**LEE COUNTY, FLORIDA
DEPARTMENT OF COMMUNITY DEVELOPMENT
ZONING DIVISION
STAFF REPORT**

TYPE OF CASE: PLANNED DEVELOPMENT/DCI
CASE NUMBER: BERMUDA LAKES RV RESORT RVPD
HEARING EXAMINER DATE: NOVEMBER 12, 2014

Applicant: Exit 24 LLC
In reference to The Bermuda Lakes RV Resort RVPD

Request: Rezone 48.73± acres from Residential Planned Development (RPD) and Industrial Planned Development (IPD) to Recreational Vehicle Planned Development (RVPD) to allow the property to be developed with a transient recreational vehicle park with up to 200 lots and related accessory uses. Potable water and sanitary sewer services will be available by Lee County Utilities. No blasting is proposed.

SECTION A-A

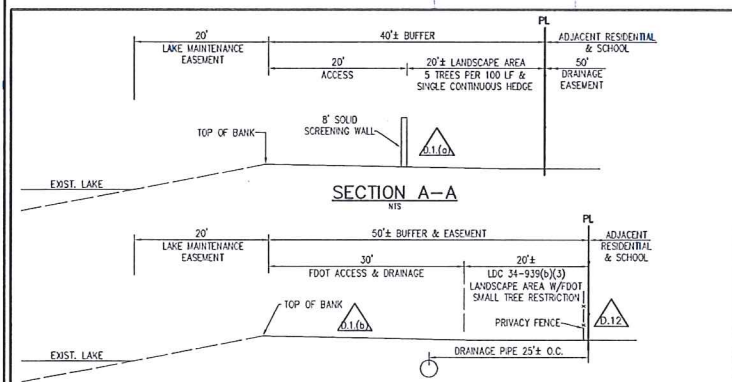
11. **Buffer (Section A-A):** Development order landscape plans must depict the north property buffer consistent with the MCP Section A-A to provide:
 - an 8-foot in height wall located 20-feet off the perimeter property line; and

- a 20-foot wide planted landscape buffer containing five trees per 100 linear feet, 10-foot in height 2-inch caliper and/or palms a minimum 10-foot clear trunk at time of planting, and a single continuous hedge, 24-inch in height at time of planting maintained at a minimum 36-inches, to be located on the exterior of the wall; and

- a 20-foot wide lake maintenance access drive located on the interior side of the wall.
OR
 - If a wall is not proposed then LDC Section 34-939(b)(3) plantings must be provided within the 20-foot wide planting area.

SECTION B-B

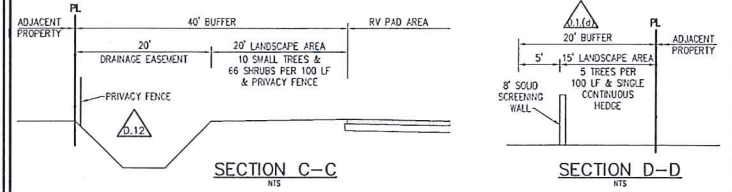
12. **Buffer (Section B-B):** Development order landscape plans must depict the north property buffer consistent with the MCP Section B-B to provide:
 - a 20-foot wide landscape buffer planted as per 34-939(b)(3) requirements with the option to use mid-story trees as per the FDOT Easement Agreement Instrument #2009000074398; and

- a 30-foot wide FDOT access drive for drainage maintenance and a portion of the internal road cul-de-sac as depicted on the MCP North Boundary Buffer Detail;
OR

- If written authorization is obtained from FDOT to allow an 8-foot in height wall within the existing FDOT easement then the buffer plantings, wall, and access drive as depicted in MCP Section A-A and conditioned in Deviation 1a along with the cul-a-sac can be provided.

SECTION D-D

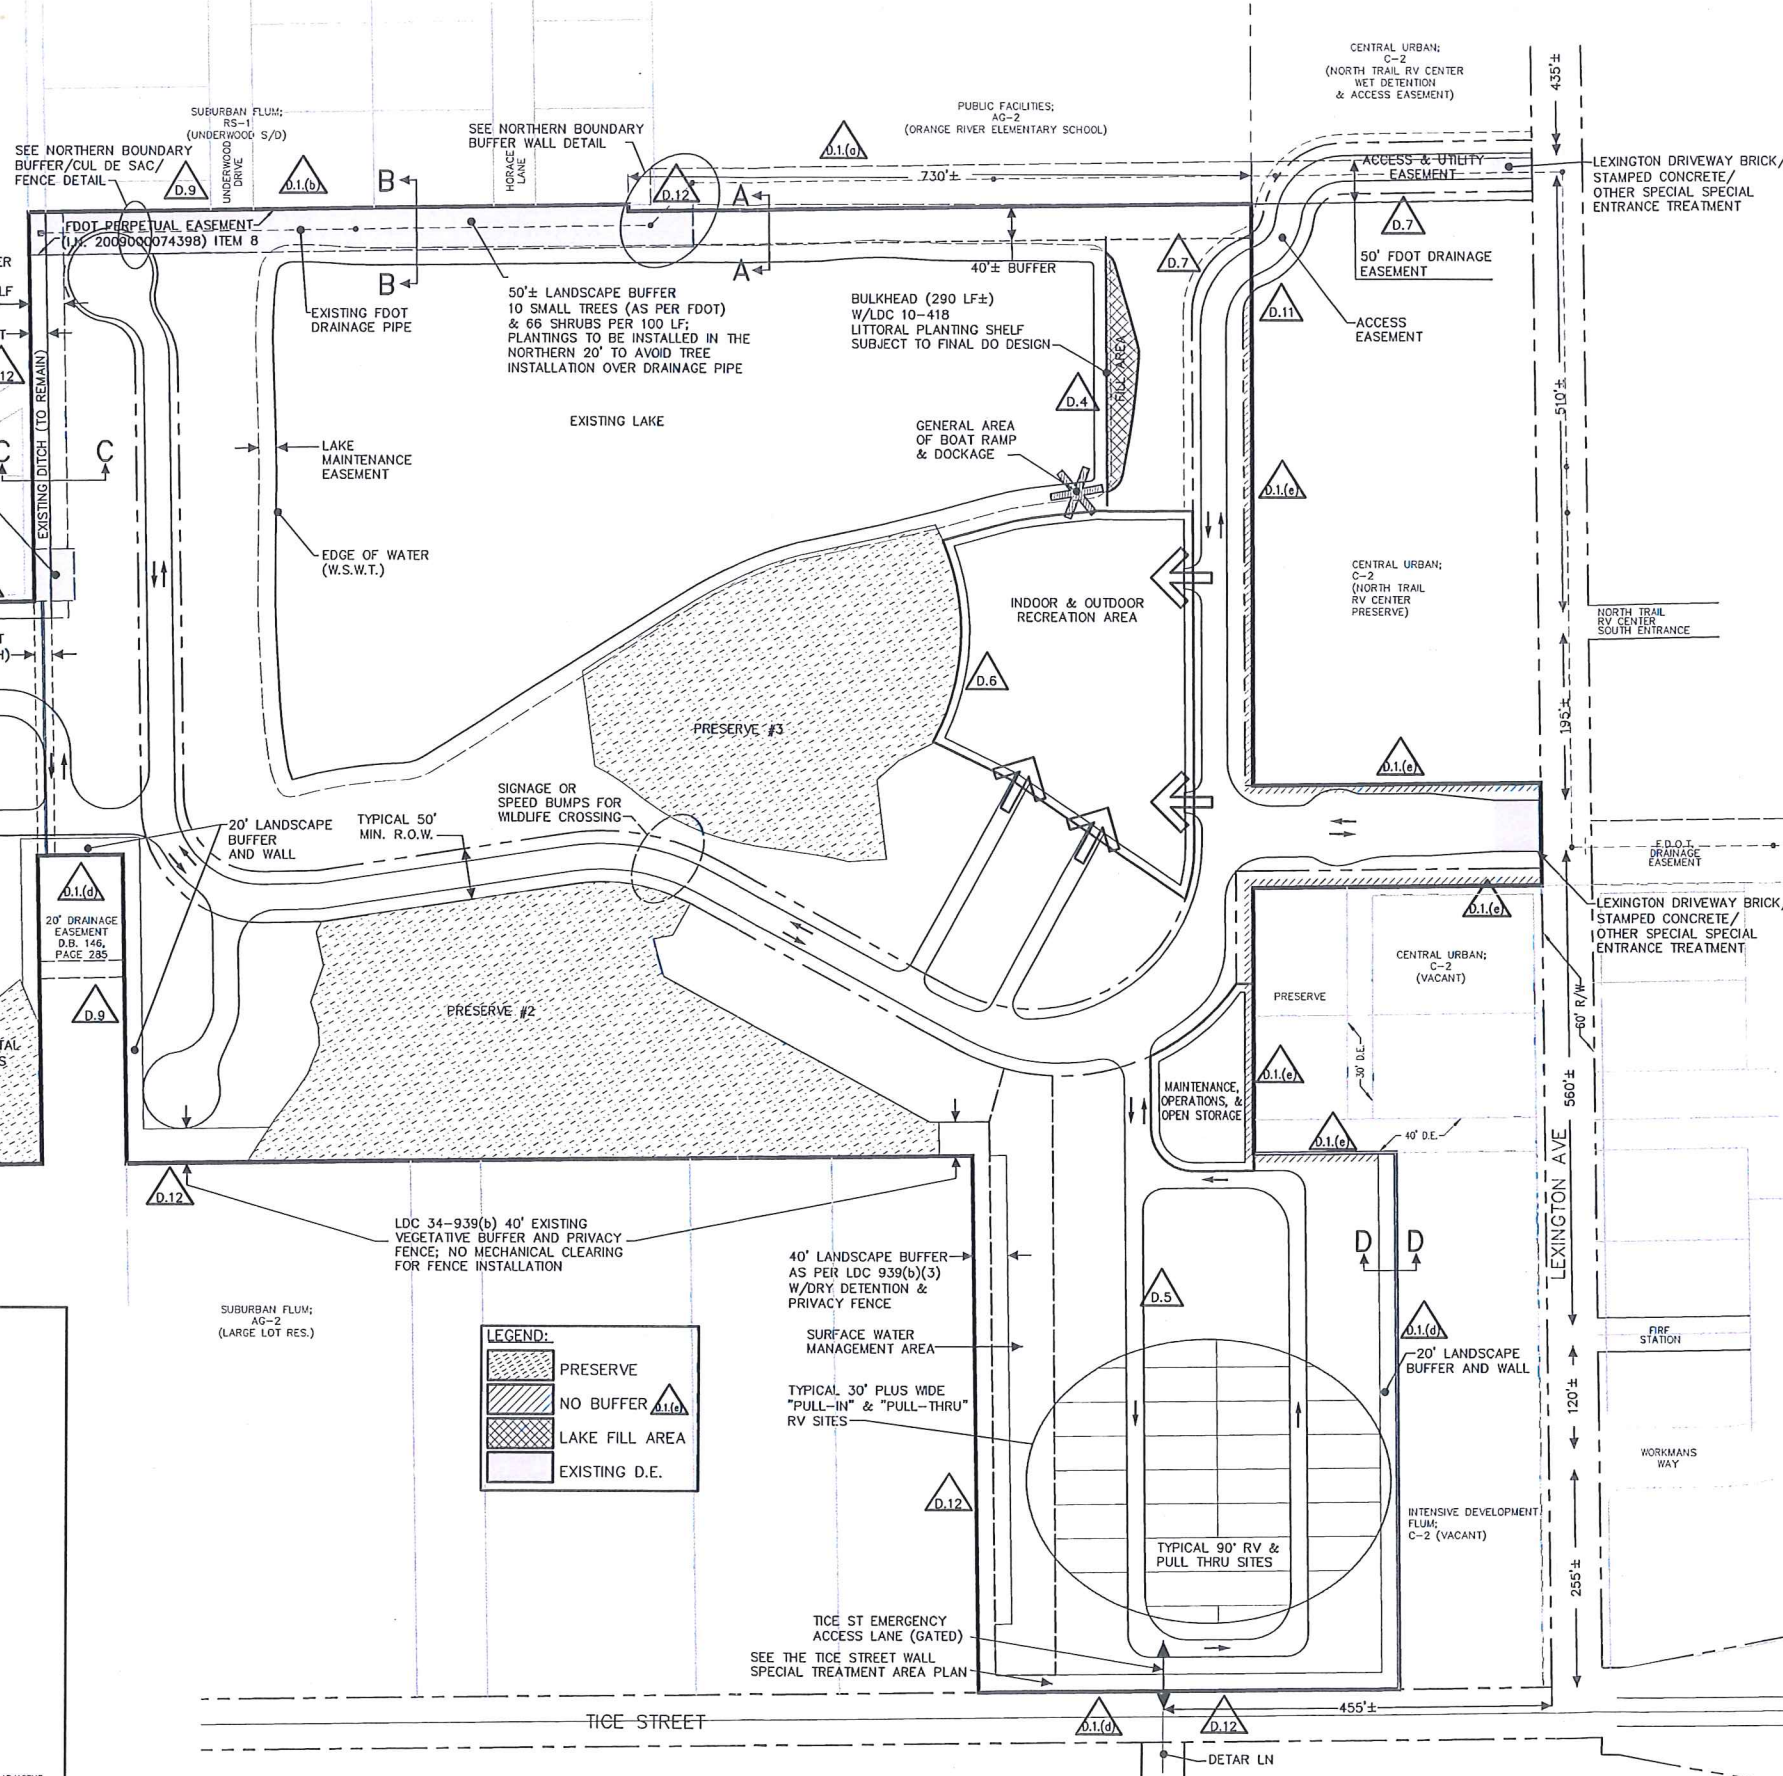
13. **Buffer (Section D-D) and Tice Street Wall Special Treatment Buffer Plan:** Development order landscape plans must depict the perimeter buffer at specified locations consistent with the MCP Section D-D to provide:

- an 8-foot in height wall located a minimum 15-feet off the perimeter property line; and
- a planted landscape buffer to be located on the exterior of the wall, containing five trees per 100 linear feet per LDC Section 34-393(b)(3) planting standards and a single continuous hedge, 24-inch in height at time of planting maintained at a minimum 36-inches; AND

The Tice St. Wall Special Treatment Buffer Plan

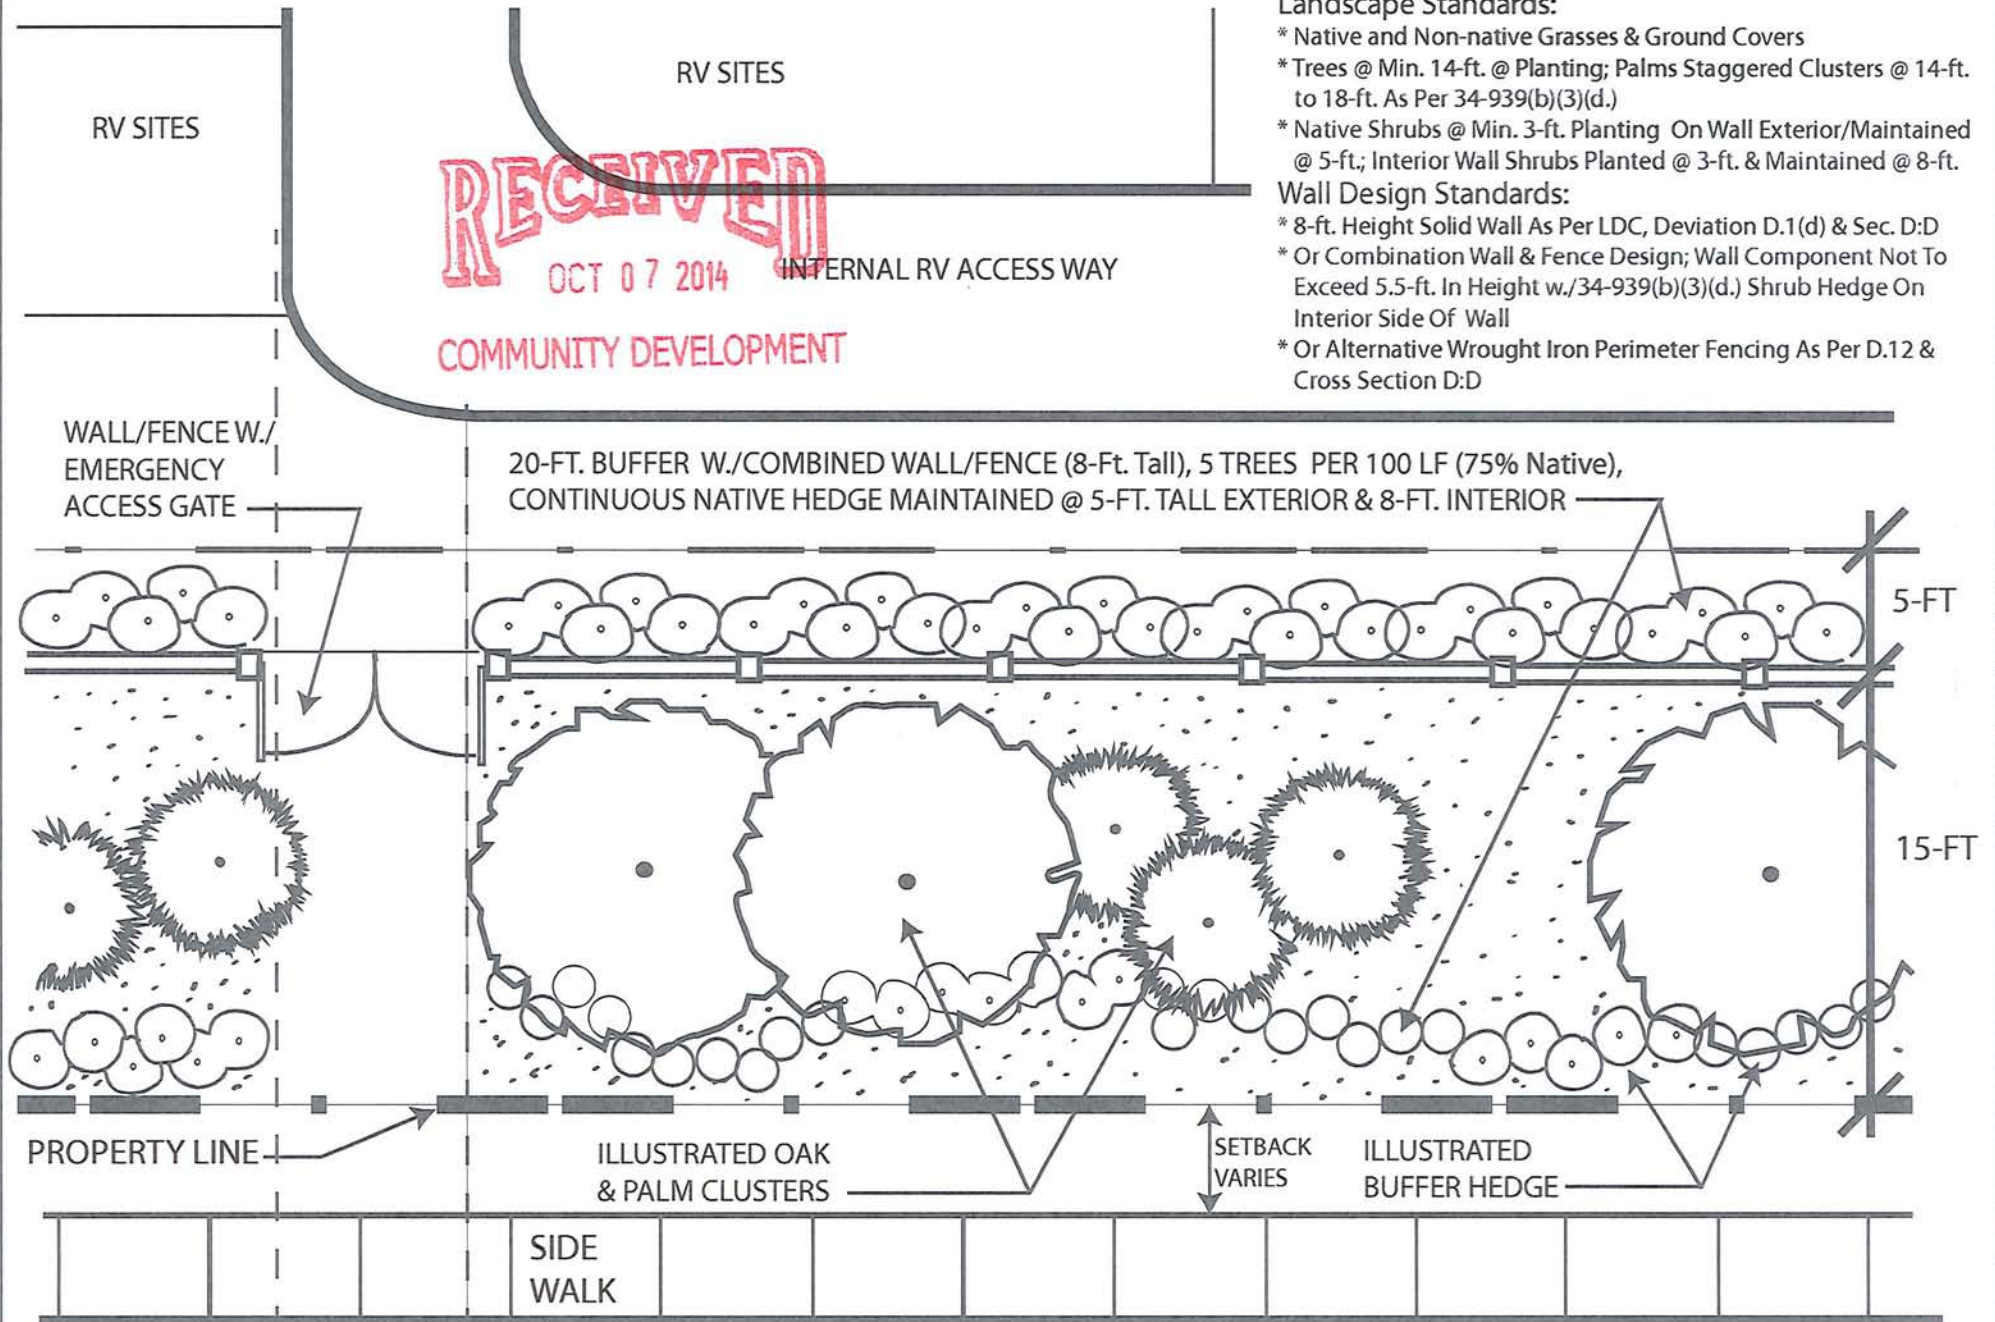
The Tice Street right-of-way buffer segment consistent with the “Tice Street Wall Special Treatment Buffer Plan” Exhibit (See 2-Page Exhibit K) to provide:

- either an 8-foot in height combination wall and fence with 5-trees per 100 linear feet per LDC Section 34-939(b)(3) planting standards except that the buffer will have a single continuous hedge exterior to the combination wall/fence planted at 3-feet maintained at a minimum 5-feet and a have a single continuous hedge interior to the combination wall/fence planted at 3-feet maintained at a minimum 8-feet; OR
- an alternative wrought iron fence with the 20-foot buffer planted as per LDC Section 34-393(b)(3) planting standards. The required buffer vegetation may be located on the interior of the wrought iron fence consistent with Deviation #12.
